## **ADDENDUM NO. 1**

### **H34-I360**

### **North Campus Blvd Repair Improvements**

SHEET NO. 1

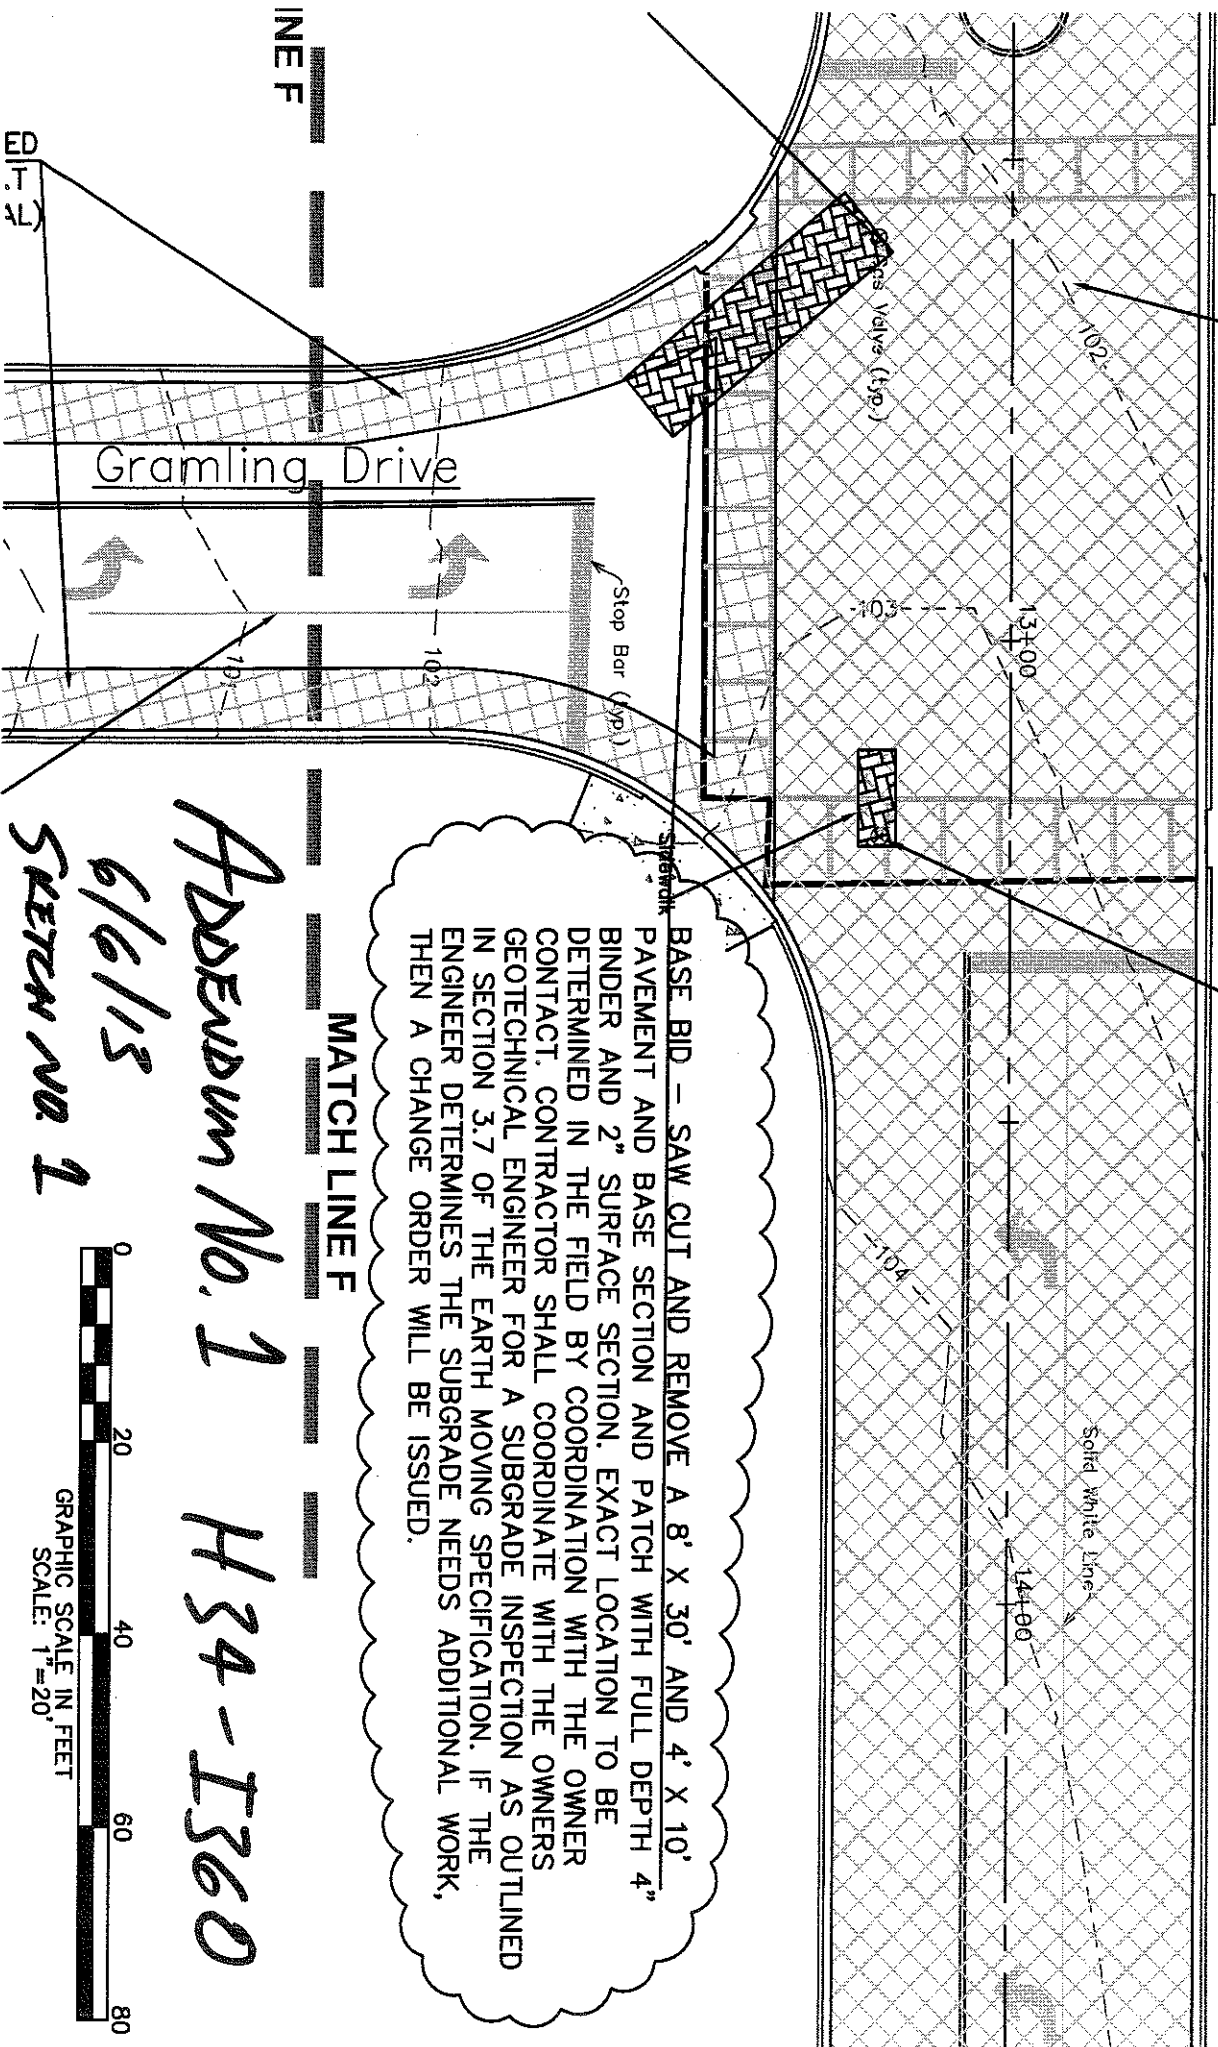
2" DEEP FULL  
SECTION MILL  
BASE BID

BASE BID - SAW CUT AND REMOVE A 8' X 30' AND 4' X 10' PAVEMENT AND BASE SECTION AND PATCH WITH FULL DEPTH 4" BINDER AND 2" SURFACE SECTION. EXACT LOCATION TO BE DETERMINED IN THE FIELD BY COORDINATION WITH THE OWNERS CONTACT. CONTRACTOR SHALL COORDINATE WITH THE OWNERS GEOTECHNICAL ENGINEER FOR A SUBGRADE INSPECTION AS OUTLINED IN SECTION 3.7 OF THE EARTH MOVING SPECIFICATION. IF THE ENGINEER DETERMINES THE SUBGRADE NEEDS ADDITIONAL WORK, THEN A CHANGE ORDER WILL BE ISSUED.
